SAN ANTONIO WATER SYSTEM
Addendum No. 1
To
Construction Documents
For
2011 WATER & SEWER CONSTRUCTION PACKAGE IV
SAWS WATER JOB NO. 11-5006
SAWS SEWER JOB NO. 11-5506
Solicitation #B-11-012-DD

Add PAGE M-12

M-12

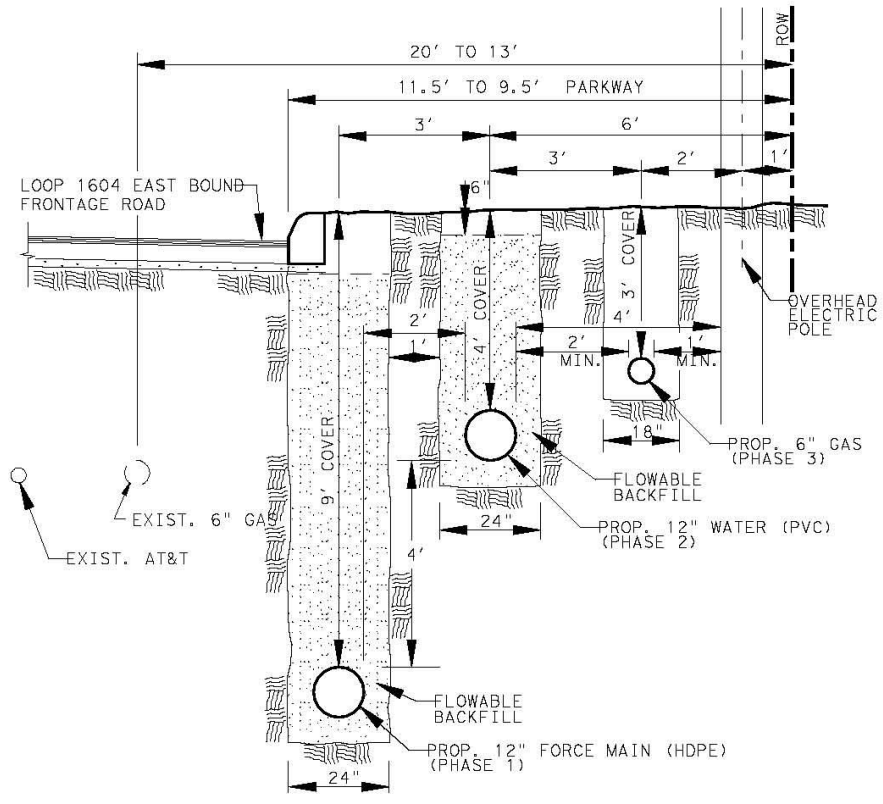
Add detail for US 281 N / Loop 1604 Interchange Project
Trench detail for separation distance between proposed main.

WQ15 On the 1604 & 281 work order, there is a note that states for us to see trench detail showing the separation between proposed mains. Where can we view the detail referenced in this note?

Response: *Yes, the detail provided within Addendum No. 1 will show the approximate amount of flowable fill that will be required for the US 281 / Loop 1604 Interchange project.*

Response: *The detail is being provided within Addendum No. 1*
